Capscrew & Stud Fastener Locations for Dana 34-44,000 lbs Tandem Axle Models – After 6/3/02*

Carrier Mounting Flange Design Change

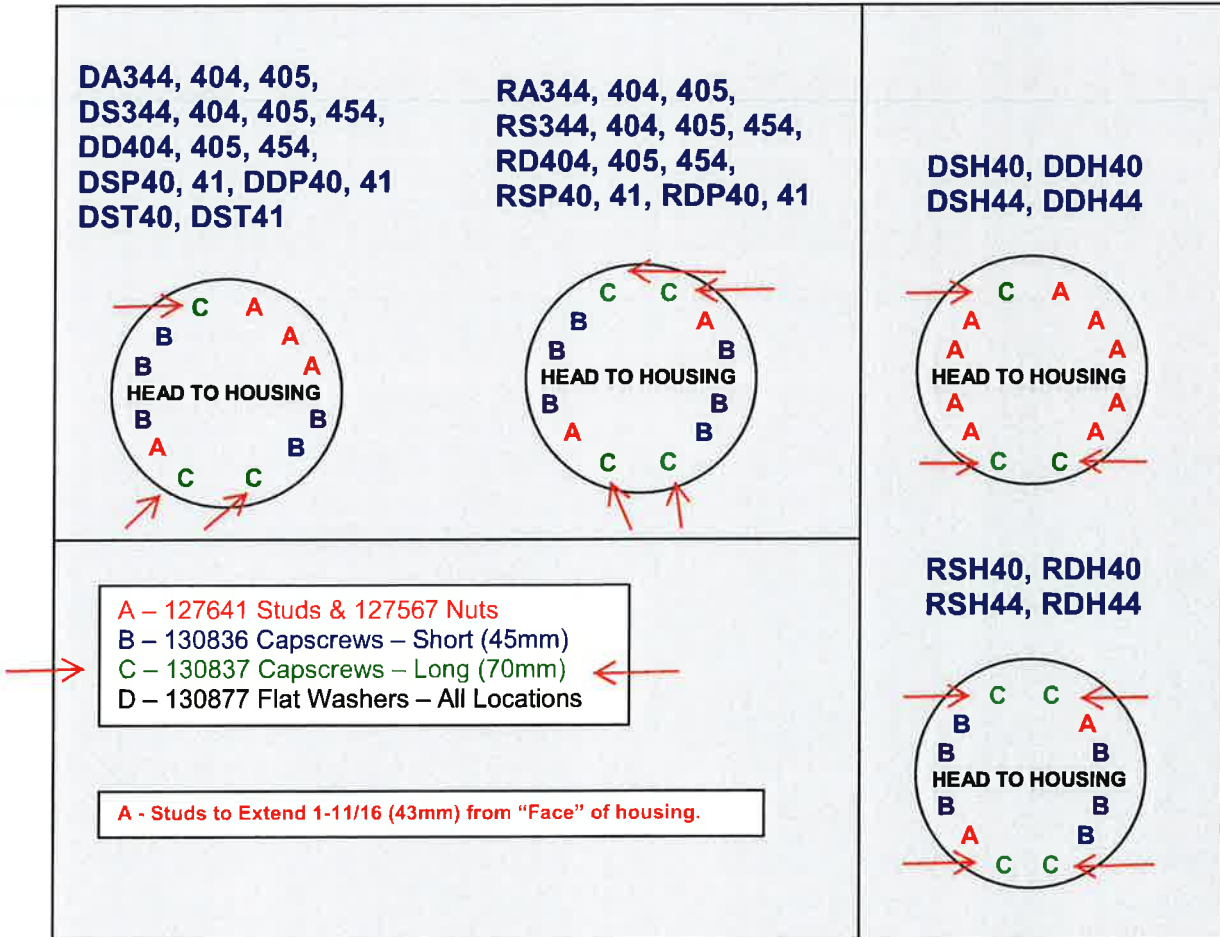
DESIGN CHANGE: The nominal thickness of the carrier to housing flange has been increased on both the forward and rear-rear axles. This change will require the use of new fastener parts. A new (45mm) capscrew (P/N 130836) has been released. Additionally, a much thicker boss has been added to the flange at the 12:00 & 6:00 o'clock positions. These new thicker flange bosses will require an even longer capscrew (P/N 130837). A thicker and larger diameter flat washer (P/N 130877) has also been released as part of this upgrade. The existing stud (P/N 127641) and nut (P/N 127567) will continue to be used. Refer to page 5 for specific washer, capscrew and stud details and locations.

New Dana "Thick Flange" Carriers Require New Longer Style Capscrews at the 12:00 & 6:00 o'clock Positions.

DESIGN CHANGE: New fasteners were released for the thick flange carriers as described above. Shown below are the new fastener parts along with a "fastener replacement" chart for reference. A new "Axle Housing Hardware" kit (P/N: 512087) has been released for use with all "thick flange" design carriers.

New Longer Capscrews –
DANA P/N's 130836-(70mm),
130837-(45mm)

New Wider & Thicker Flat
Washer – DANA P/N 130877
